SAP-17-101: 3475 Piedmont Road
Zoned: SPI-12 SA-1

Summary: The Applicant is proposing the construction of a new 322 unit multi-family development with a minor retail component.

Modera – Prominence Variation List
SAP-17-101

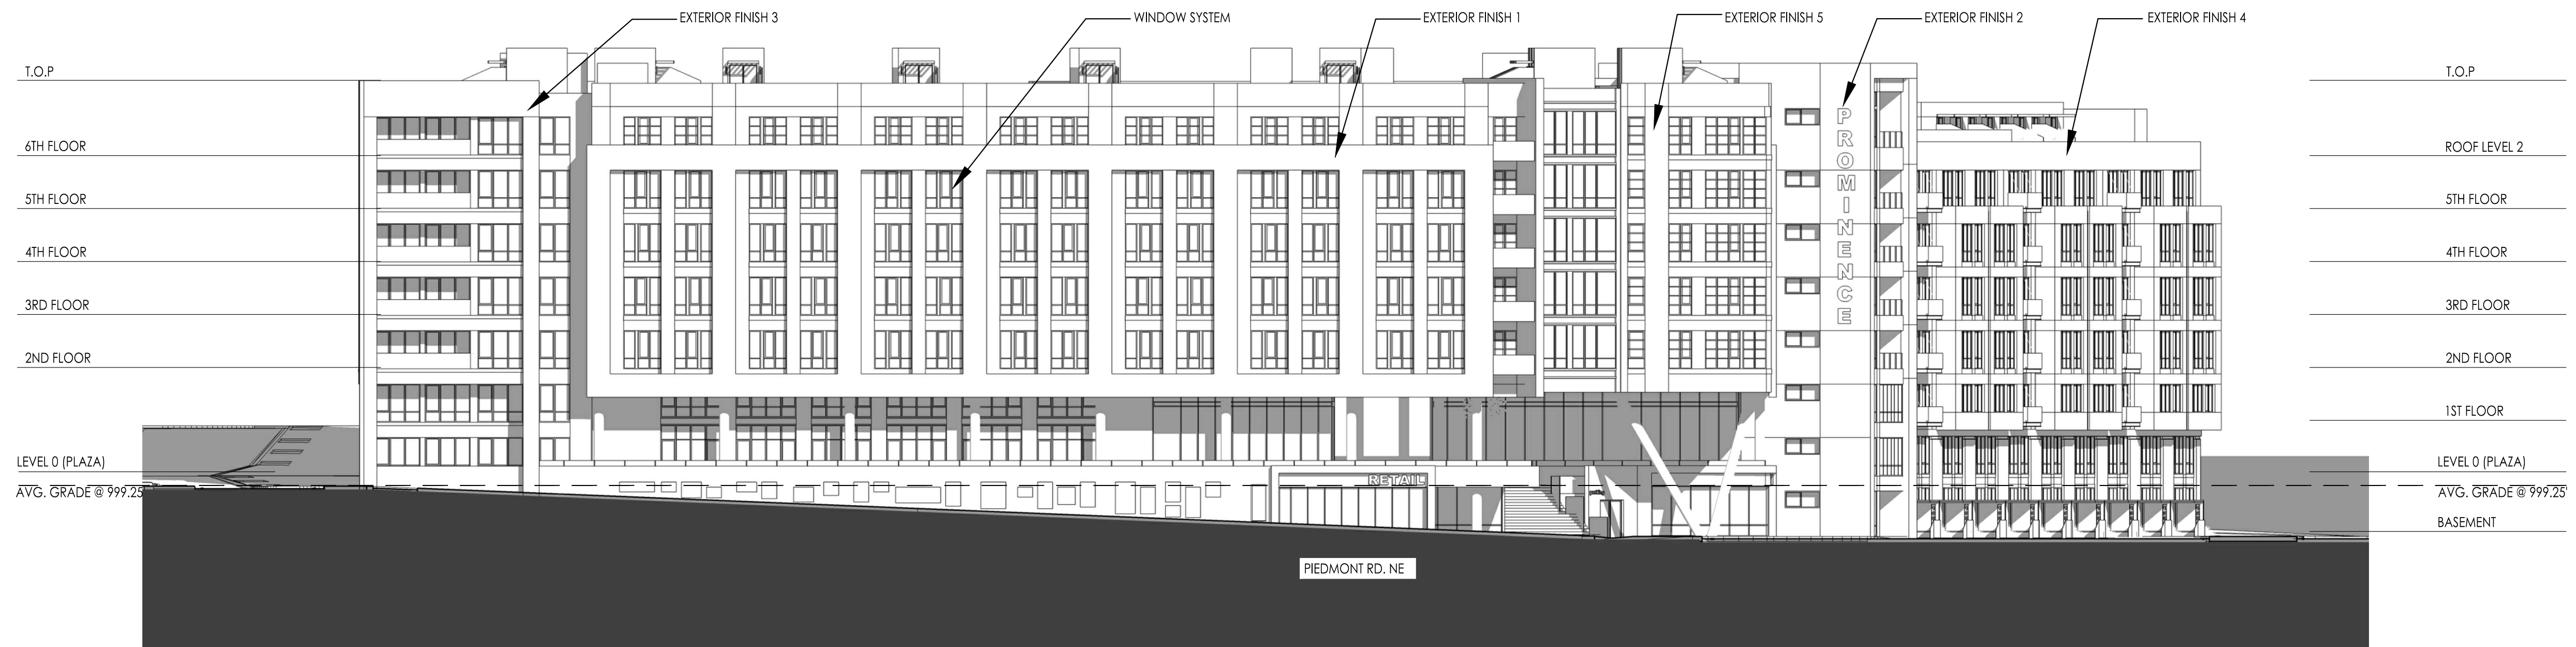
- *All residential uses located above the major sidewalk level shall provide a sidewalk-level entrance through either a lobby or similar space.*
- *Show all building entrances on elevations and site plan.*

1 PLAZA / 1ST FLOOR PLAN
 SCALE: 1" = 160'-0"
 REF SHEET: 2

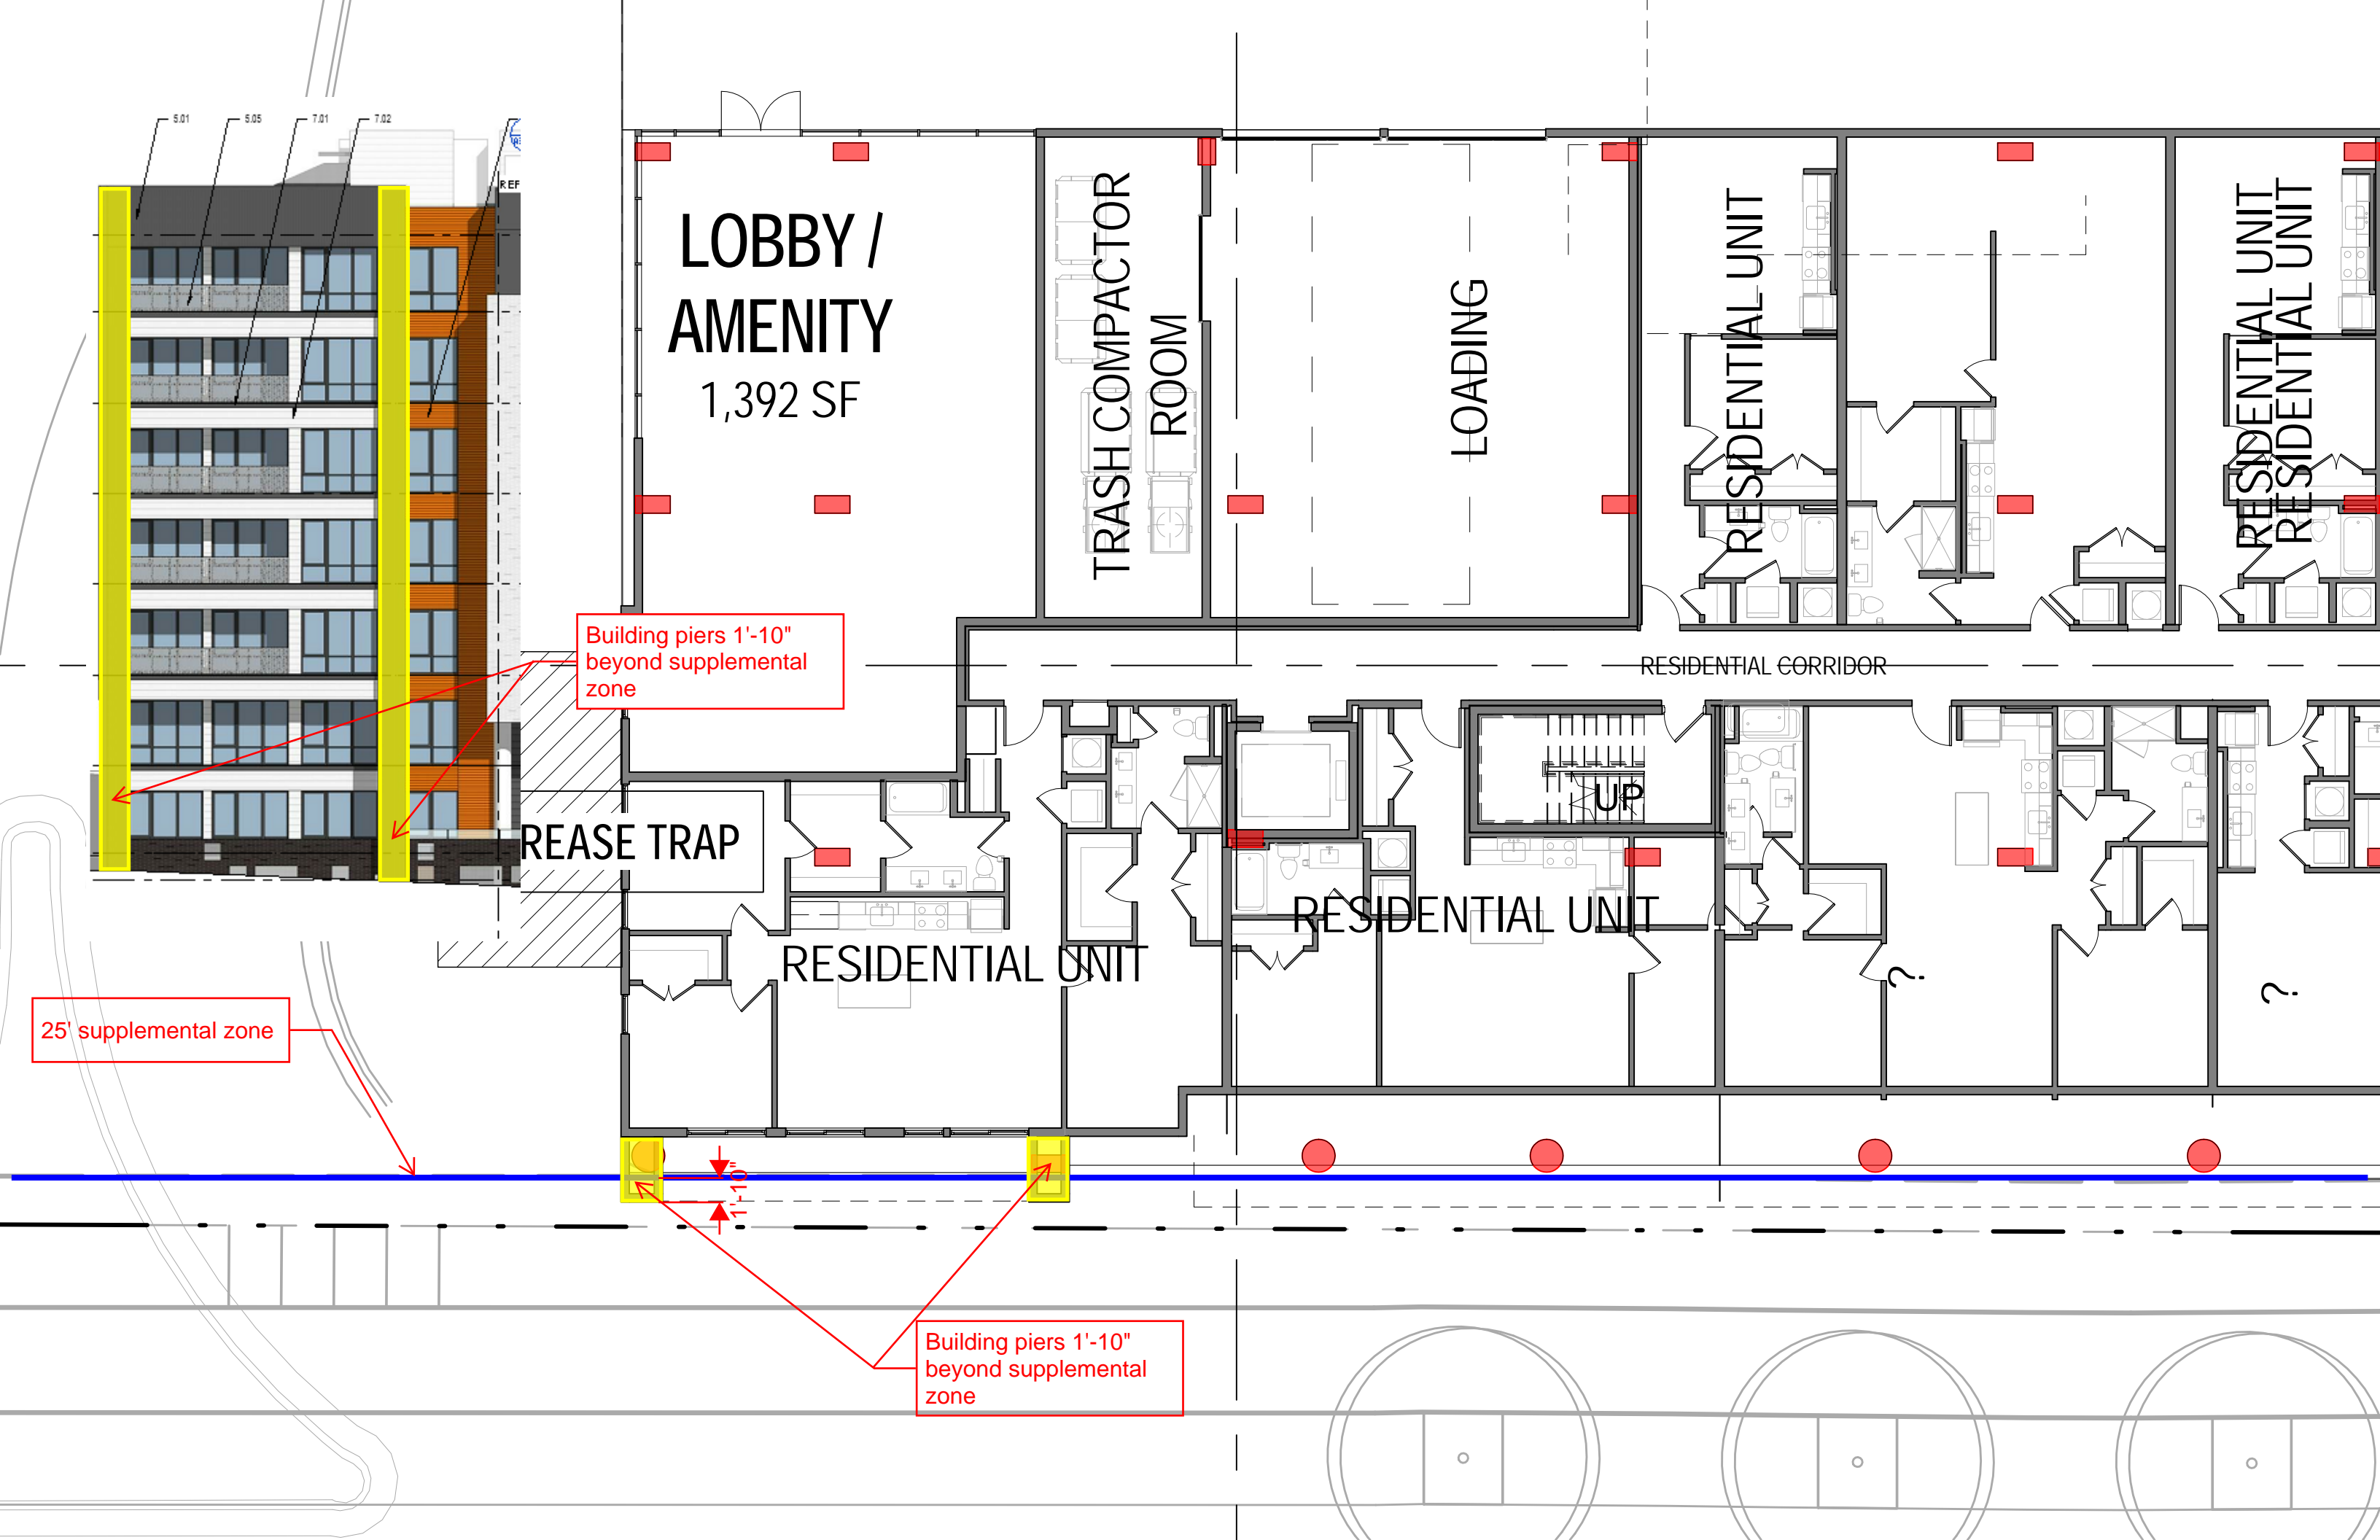
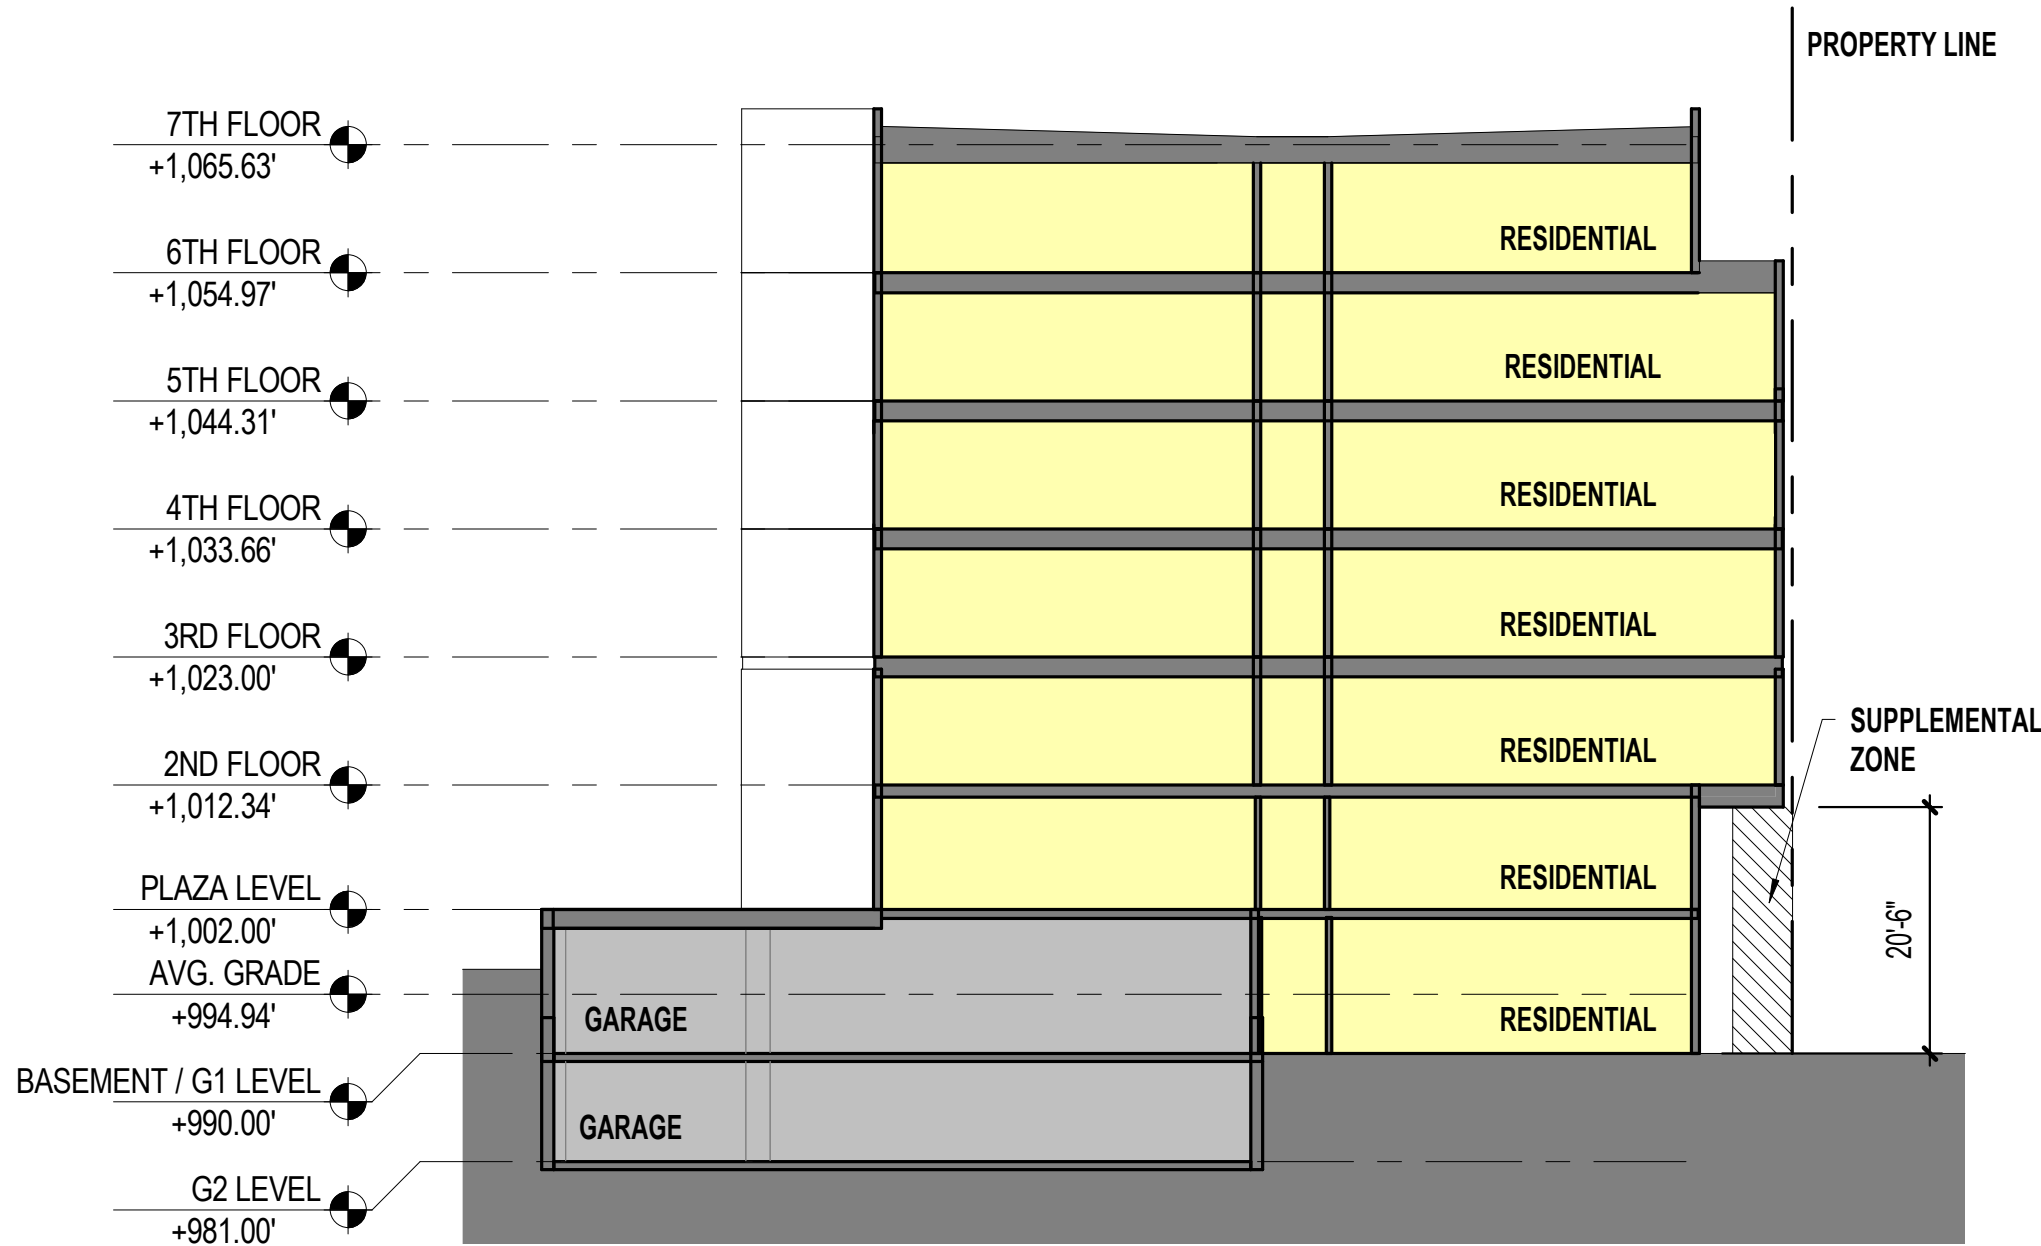
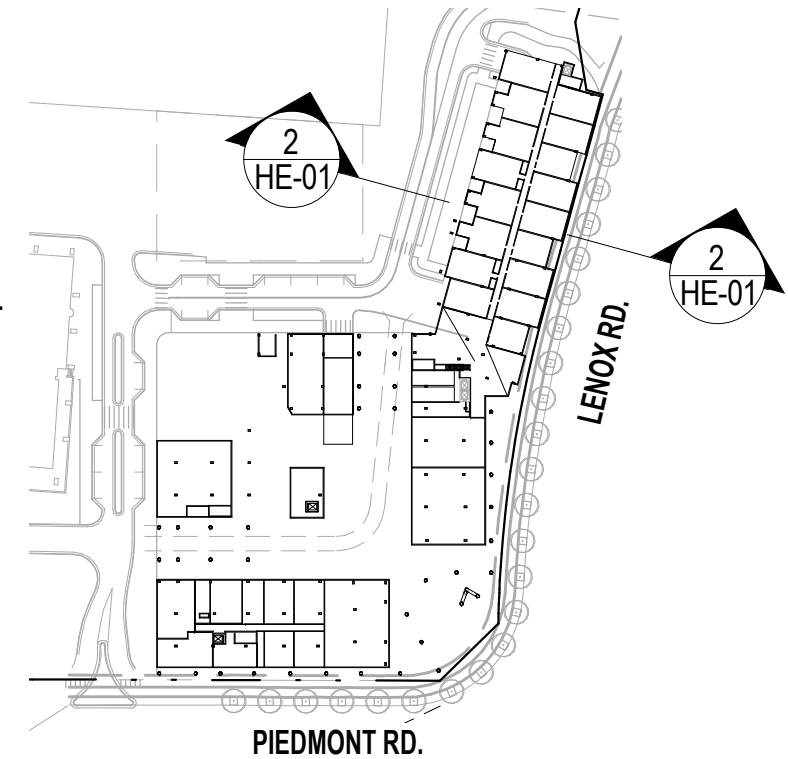
Building piers 1'-10"
beyond supplemental
zone

Building piers 1'-10"
beyond supplemental
zone

5. Section 16-18L.010 – Variation to allow two 1 foot 10 inch by _____ wide encroachments into the supplemental zone on Piedmont Road.

The applicant is proposing two vertical columns along the western portion of the Piedmont Road façade near the existing curb cut on Piedmont Road. The columns are architectural features that break up the façade on Piedmont Road and establish the entry corner. The columns encroach into the supplemental zone by 1 foot 10 inches and are shown on the elevation and highlighted in yellow on the exhibit included in this submittal. To require the applicant to comply with the supplemental zone requirement for this minimal aesthetic encroachment would create an undue hardship.
